Rocglen Coal Mine Extension Project

Response to Submissions

June 2011

**Rocglen Coal Mine Extension Project
Project Approval 10_0015
Response to Submissions**

Figure 1: Vegetation of project site showing location and area of EPBC Act listed ecological communities to be impacted

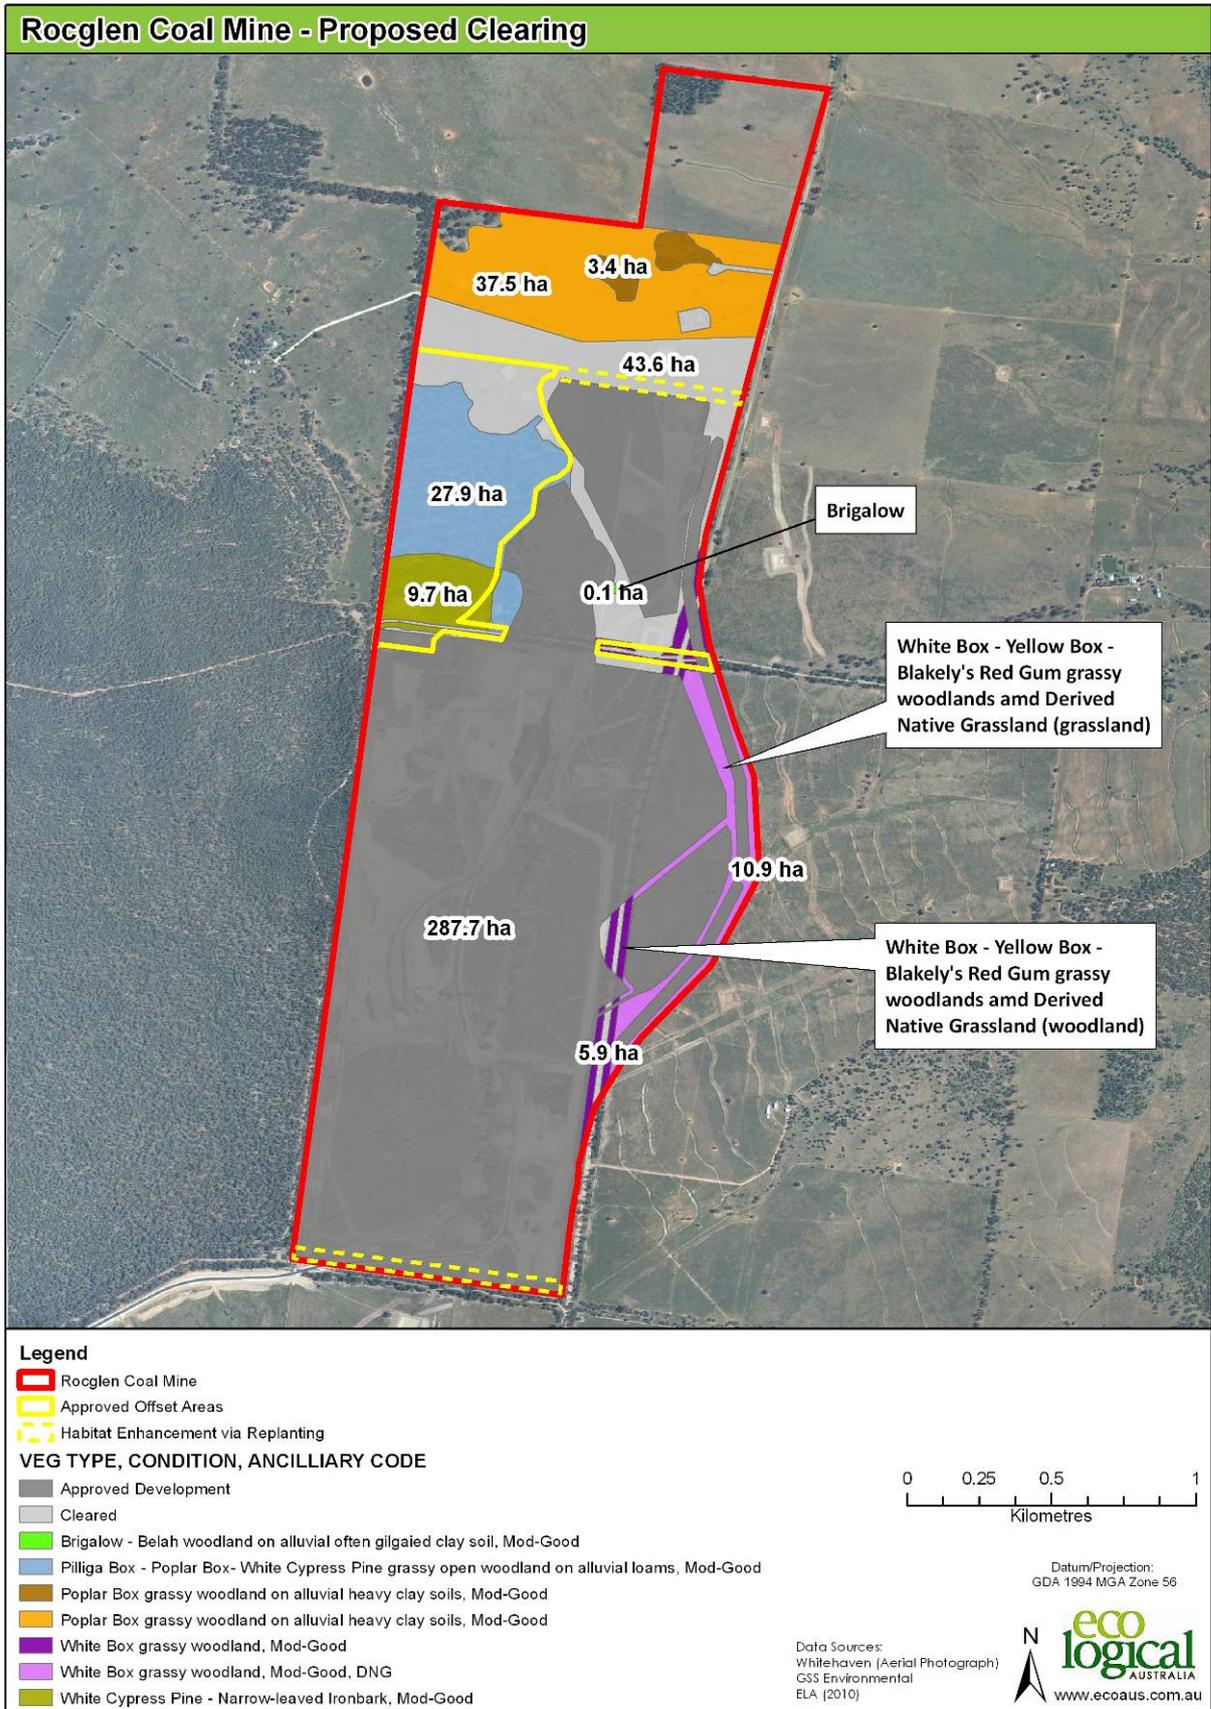
Please provide a map showing the EPBC listed ecological communities and suitable habitat for EPBC listed species within the project area.

Figure 1 in ELA's response (see **Appendix A**) comprises a plan from the *Biodiversity Offset Strategy* (ELA 2010) showing the vegetation types within the Project Site and clearly labelling the EPBC Act listed communities, the area of these communities (hectares) and location of impacts. The *Biodiversity Offset Strategy* (ELA 2010) advises that all of the remnant woodland vegetation (not derived grasslands) to be impacted (as shown on Figure 1 in **Appendix A**) is potential foraging habitat for the EPBC Act listed Swift Parrot and Regent Honeyeater, totalling approximately 46.9 hectares (the 47.04 hectares reported in the *Biodiversity Offset Strategy* has been updated to remove the 0.14 hectares of Brigalow which is not foraging habitat).

Figure 1 labels those EPBC Act listed ecological communities within the project area, the area (ha) and location of impacts. Tables 1 and 2 identify the impacts by area and condition of each EPBC Act listed community (total 16.94 ha) and area of suitable habitat for listed species (46.9 ha).

Figure 2: Regional location of Whitehaven Coal Regional Biodiversity Offset Site

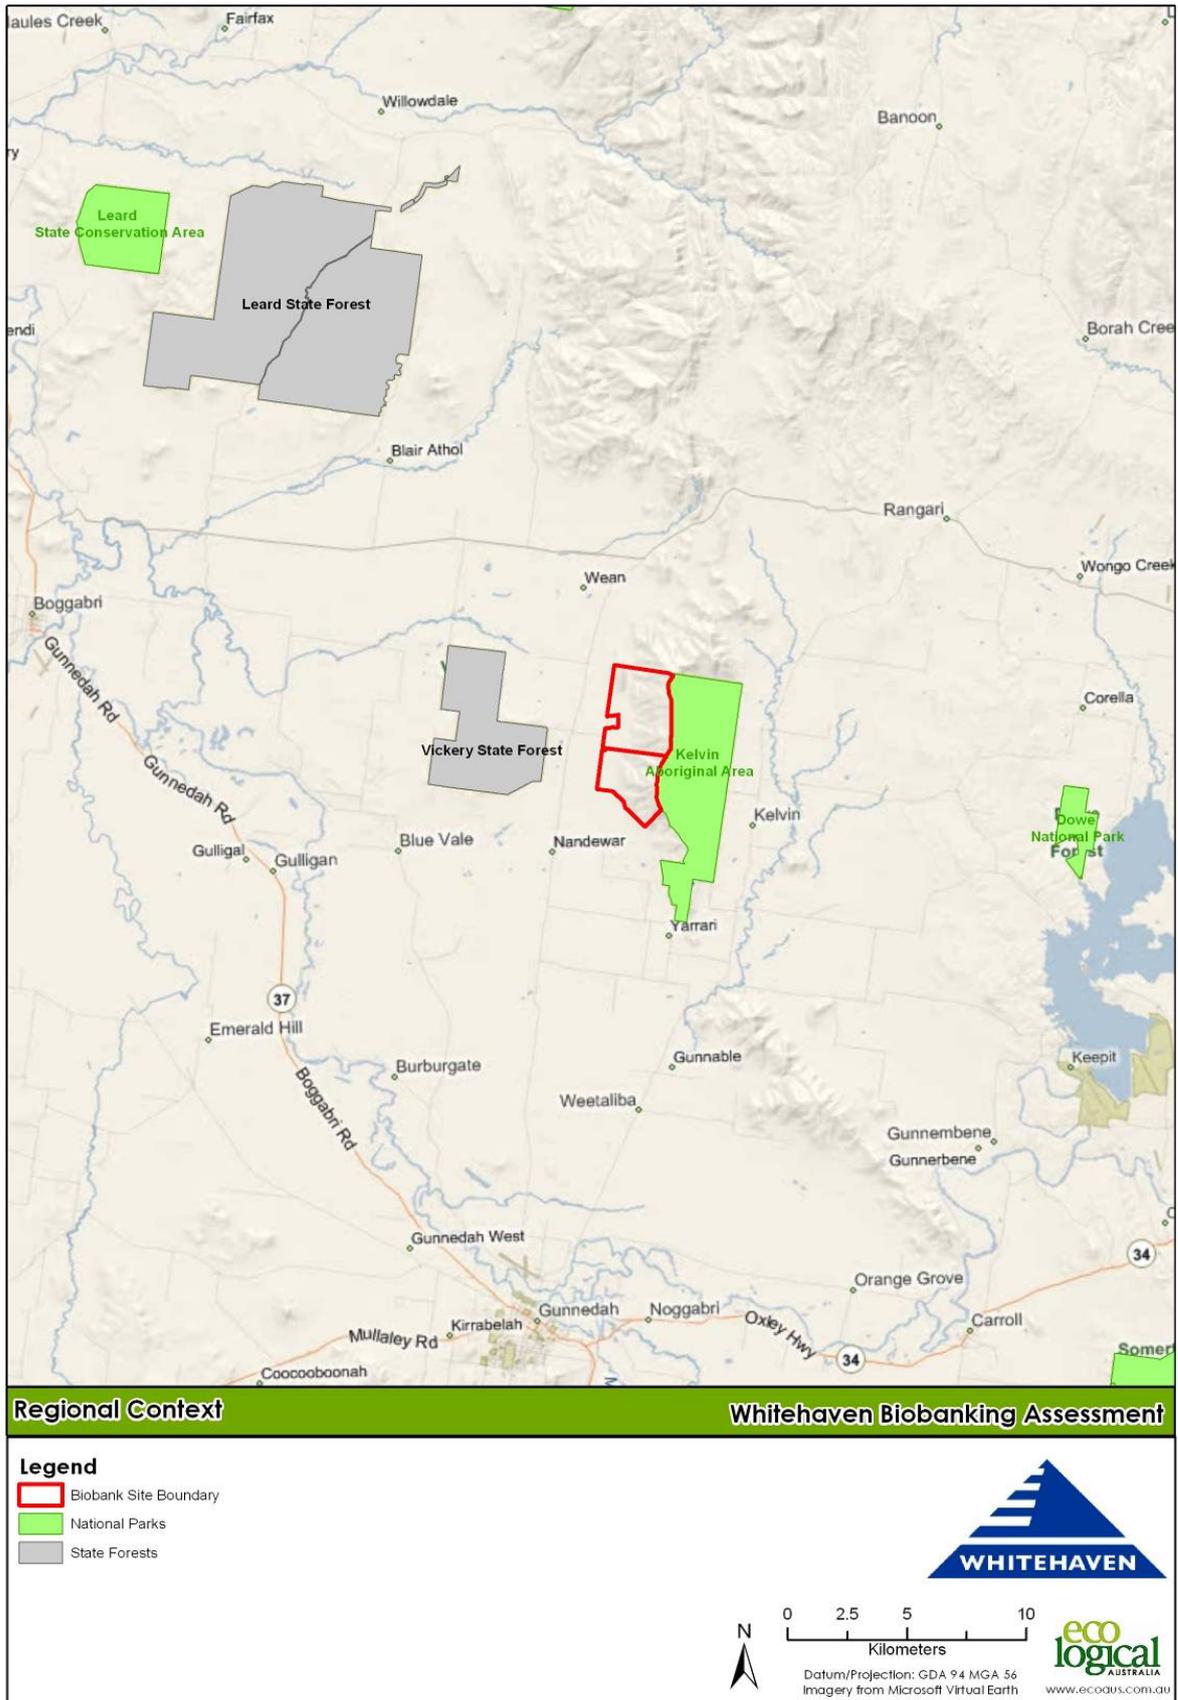
To assist in the assessing the degree of risk of future disturbance to the proposed offsets, please provide details of all identified coal resources (including current or likely exploration or mining applications or leases) in the vicinity of the proposed offset sites.

The proposed offset site is within the Whitehaven Regional BioBank Site, which is 100 percent owned by Whitehaven. **Figures 1** and **2** of this response show the regional location and expanse of the BioBank Site, including proximity to Rocglen and the adjoining Community Conservation Area (CCA) Zone 2 Kelvin. This area was formally known as the Kelvin State Forest, however is now reserved under the NSW *National Parks and Wildlife Act 1974* (NPW Act) as Aboriginal area.

FIGURE 21

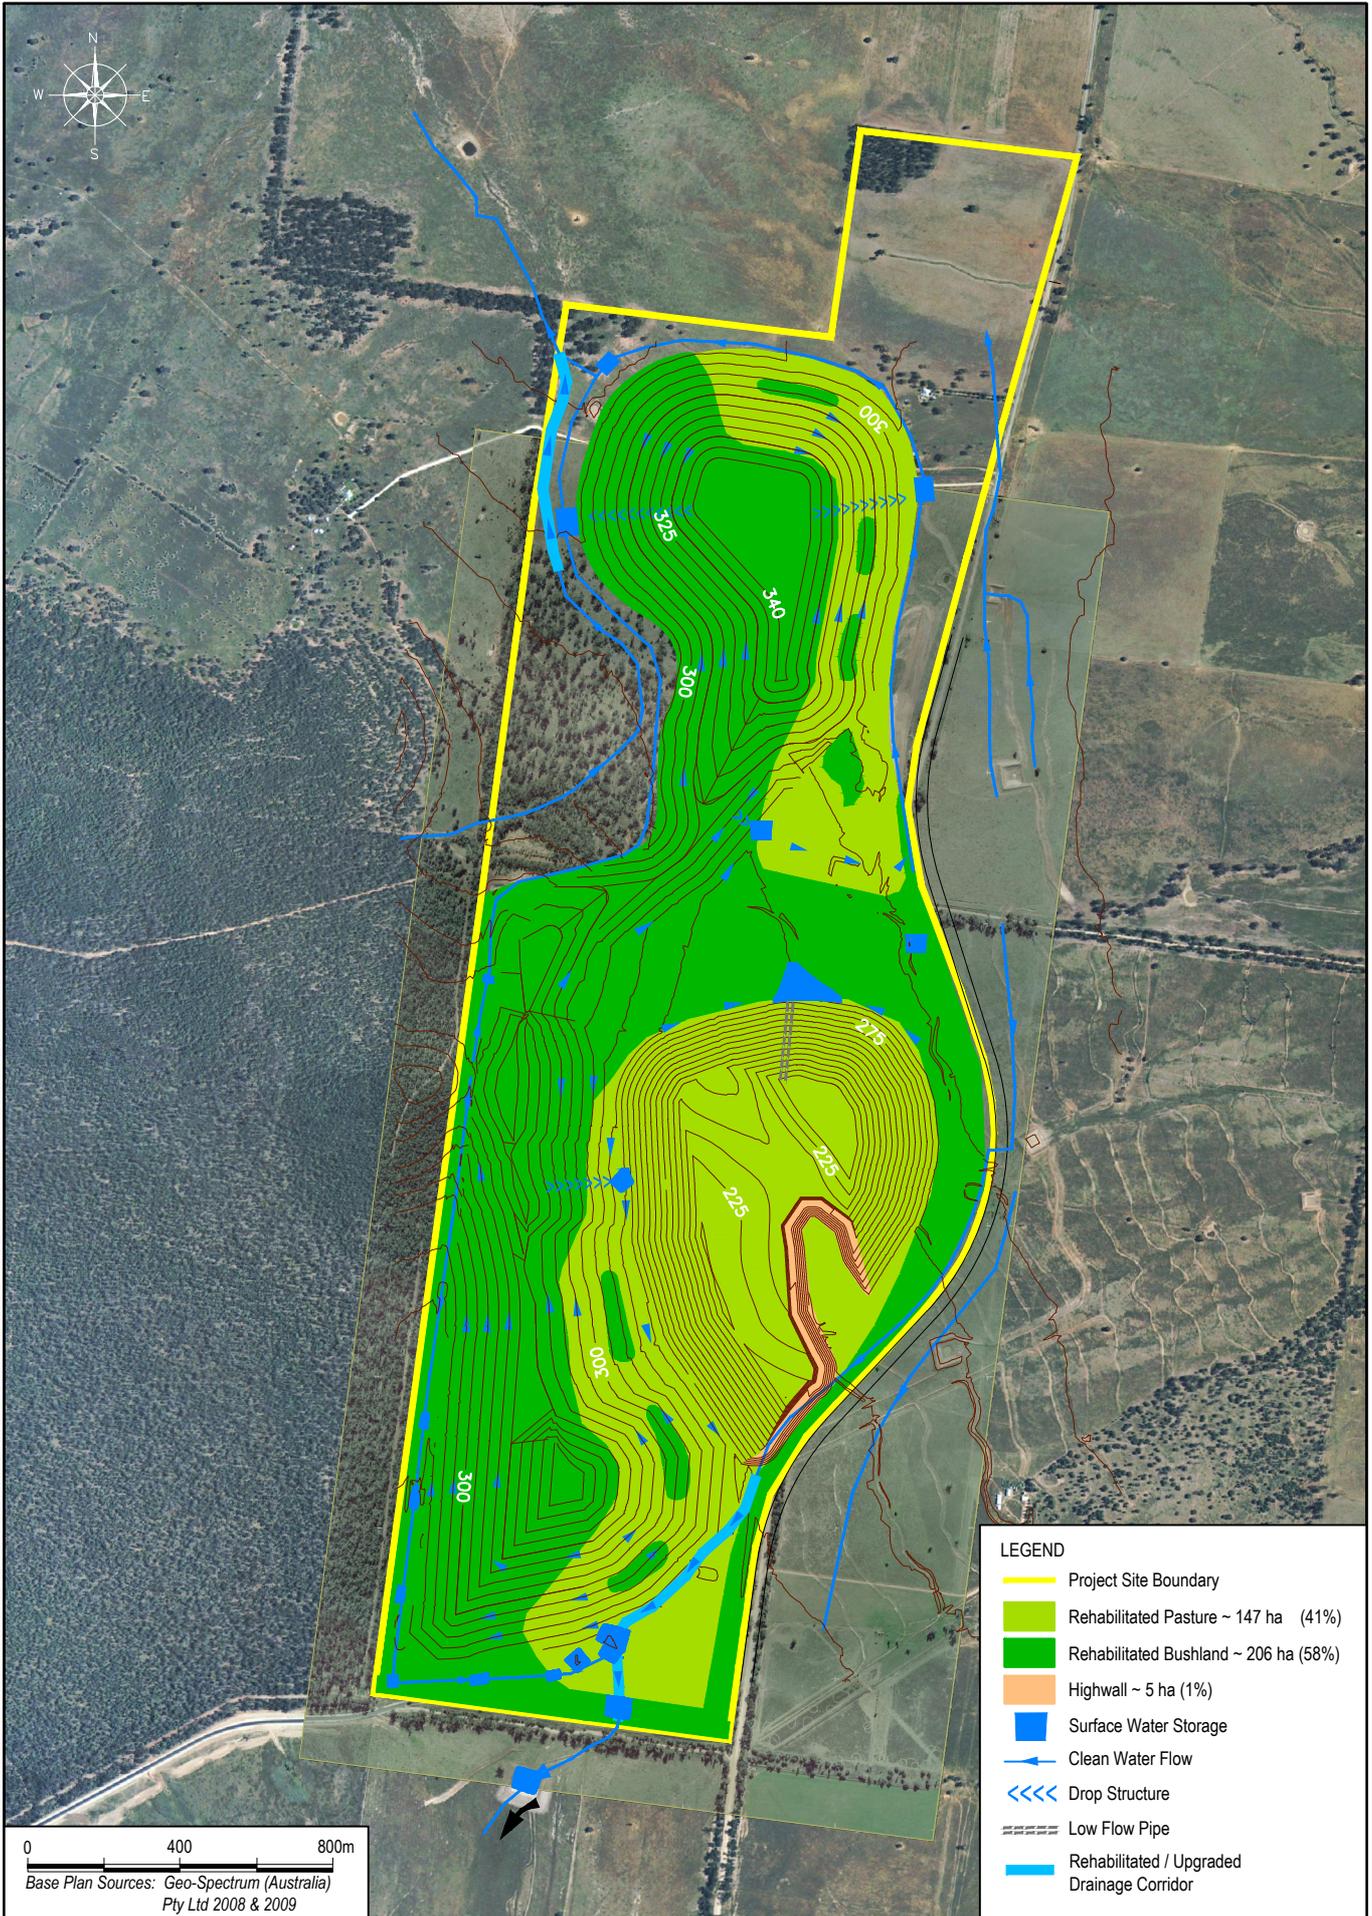
Figure 21 in the EA currently indicates that the final void area (65ha) would be returned to 'Rehabilitated Pasture'. However, as this area has been currently assessed in the EA as being Class VII and Class VIII post mining then the recommended landuse for Class VII land is 'green timber' while the Class VIII lands should not be grazed. These land capability classes and land uses are converse to the proposed landuse of 'Rehabilitated Pasture'.

Whilst land capability Class VII is generally representative of land best protected by green timber, in the case of re-establishing vegetation following mining, pasture species are often used to stabilise surface material and protect against erosion on slopes greater than 10 degrees. In fact, planting and establishing grasses/pastures on final void low walls is a standard practice. These grasses/pastures are not intended to be grazed and have therefore been classified as land capability Class VII.
